ALERT SERVICE BULLETIN
Bell Helicopter **TEXTRON**

NO. 222U-07-75

MODEL AFFECTED: 222U

SUBJECT: TAIL ROTOR PITCH CHANGE MECHANISM,
REVISED RIGGING PROCEDURES

Figure 1. Tail Rotor Pitch Change Mechanism (Position)

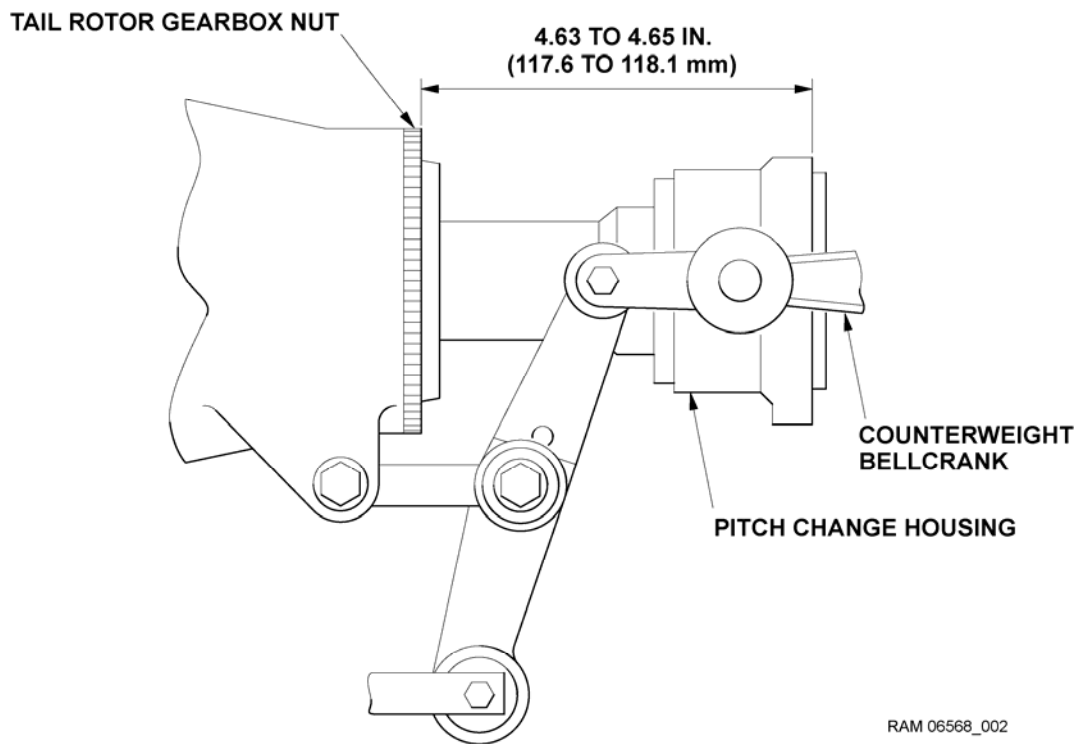
1. Move the tail rotor pedals as required and set the pitch change housing to obtain a 4.63 to 4.65 inches (117.6 to 118.1 mm) dimension as shown in Figure 1. Maintain this position.

There is no maximum limit on the gap that may exist between the tail rotor yoke and nut (4) when the pitch change housing is positioned as shown in figure 1 and the counterweight bellcranks (12) are parallel to the tail rotor gearbox output shaft.

Adjusting nut (4) and nut (8) to obtain a 0.020 to 0.030 inch (0.50 to 0.76 mm) gap between the tail rotor yoke and nut (4) will result in a minor misalignment of the counterweight bellcranks (12) in relation to the tail rotor gearbox output shaft. A maximum misalignment of 1.6 degrees of the counterweight bellcranks (12) in relation to the tail rotor gearbox output shaft is acceptable when the pitch change housing is positioned as shown in figure 1.

Figure 2. Tail Rotor Pitch Change Mechanism

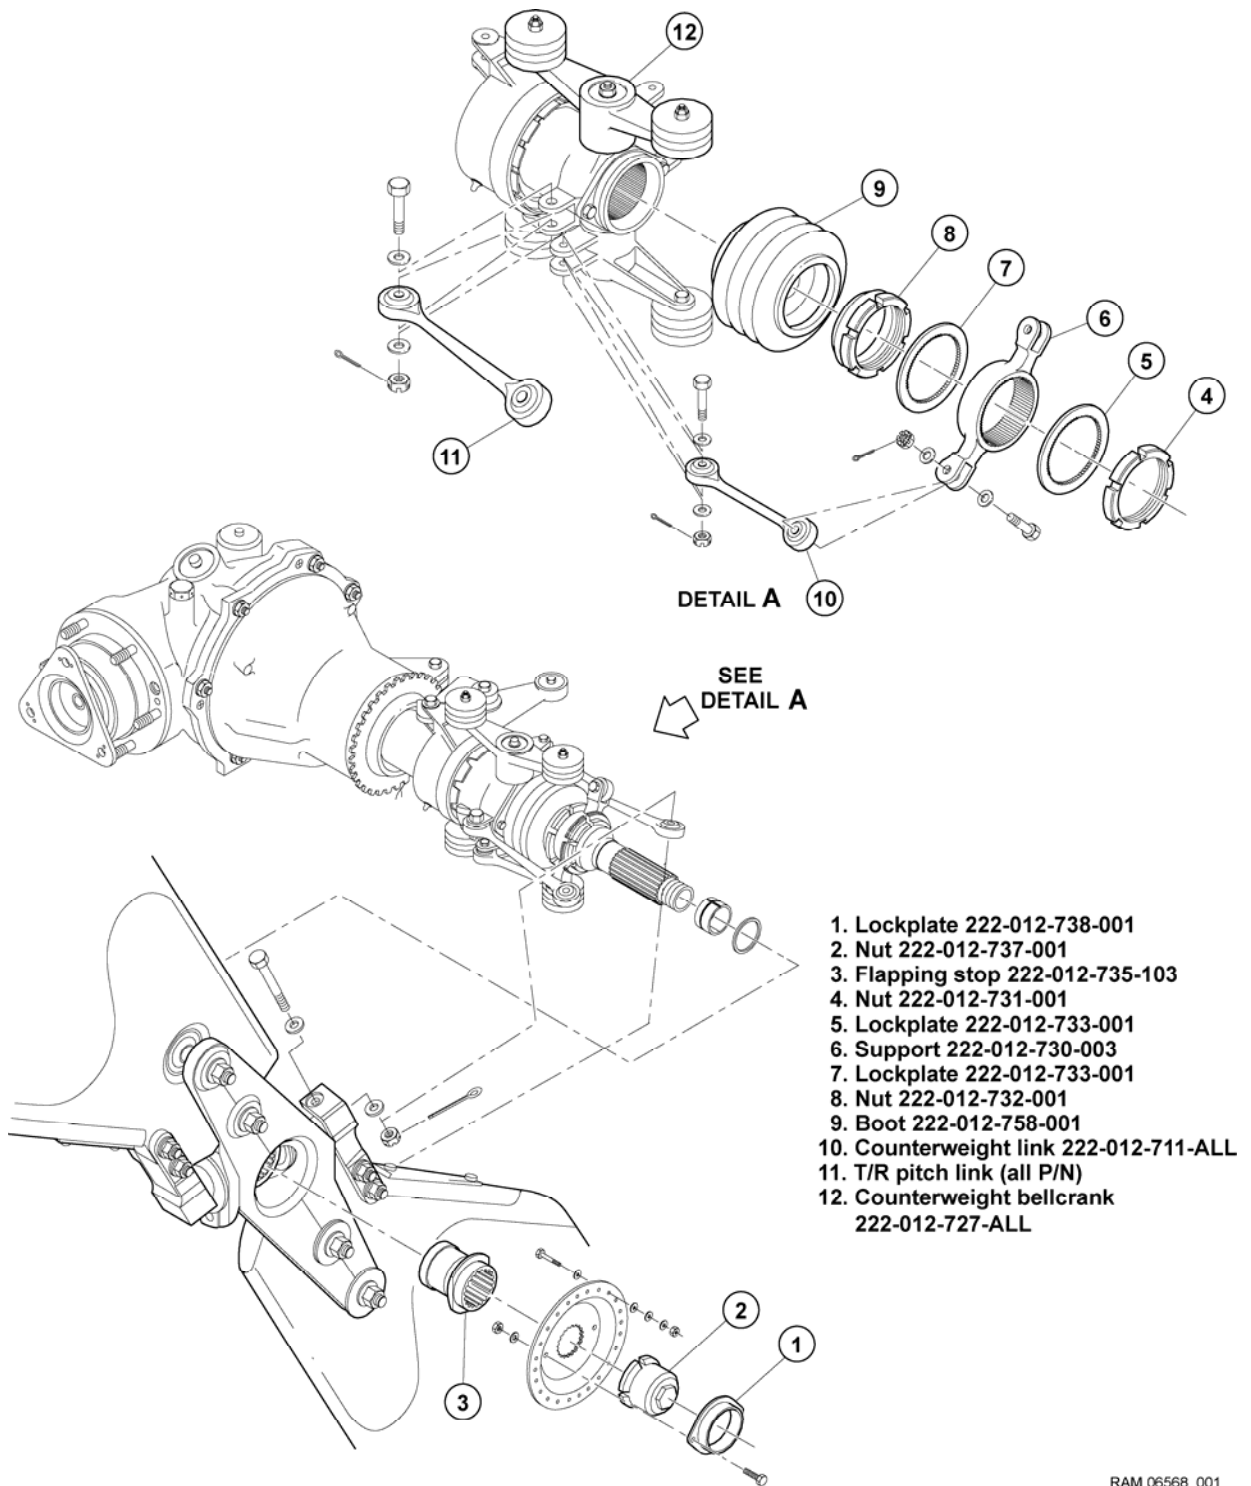
2. Verify that the centerline of counterweight bellcranks, (12, Figure 2) are parallel with the centerline of the tail rotor gearbox output shaft. If the counterweight bellcranks (12) are parallel with the centerline of the tail rotor gearbox output shaft, proceed to step 3. If the counterweight bellcranks (12) are not parallel with the centerline of the tail rotor gearbox output shaft, disconnect boot (9), pitch links (11) and counterweight links (10) as required. Straighten the bent edges of the lockplates (5 and 7) and adjust nut (4) and nut (8) to reposition support (6) until the counterweight bellcranks are parallel with the centerline of the tail rotor gearbox output shaft. Hold the nut (8) in position and torque the nut (4) to 50 to 55 foot-pounds (68 to 75 Nm). Do not bend the edge of the lockplates (5 and 7) into the slots of nut (4 and 8) at this time.

3. Move the tail rotor assembly through the full flap range (verify at both full flap positions). Verify if the tail rotor yoke touches the flapping stop (3) before it touches nut (4). If a gap exists between the flapping stop (3) and the tail rotor yoke, replace the existing tail rotor yoke with yoke P/N 222-012-702-117. Notify BHT Product Support Engineering if yoke replacement is required.

4. If there is no gap between the flapping stop (3) and the tail rotor yoke, verify if a 0.020 inch (0.50 mm) wire type feeler gauge can be inserted between the tail rotor yoke and nut (4). If the smallest gap between the tail rotor yoke and nut (4) is 0.020 inch (0.50 mm) or more, bend the edge of the lockplates (5 and 7) into the slots of nut (4 and 8). Connect boot (9), pitch links (11) and counterweight links (10) as required and proceed to step 6.

5. If the gap between the tail rotor yoke and nut (4) measures between 0.000 and 0.019 inch (0 to 0.48 mm), adjust nut (4) and nut (8) until a gap of 0.020 to 0.030 inch (0.50 to 0.76 mm) maximum exists between the tail rotor yoke and nut (4). Hold the nut (8) in position and torque the nut (4) to 50 to 55 foot-pounds (68 to 75 Nm). Bend the edge of the lockplates (5 and 7) into the slots of the nut (4) and nut (8). Connect boot (9), pitch links (11) and counterweight links (10) as required.
6. Examine and adjust the tail rotor pedal forces if any adjustments were carried out to support (6). Refer to BHT-222U-MM-7, chapter 64-00-00.
7. Annotate helicopter records to reflect compliance with this bulletin.
8. Insert the BHT-222U-MM-7 Revision 7, dated 15 Dec. 2006 into the BHT-222U-MM-7 manual.
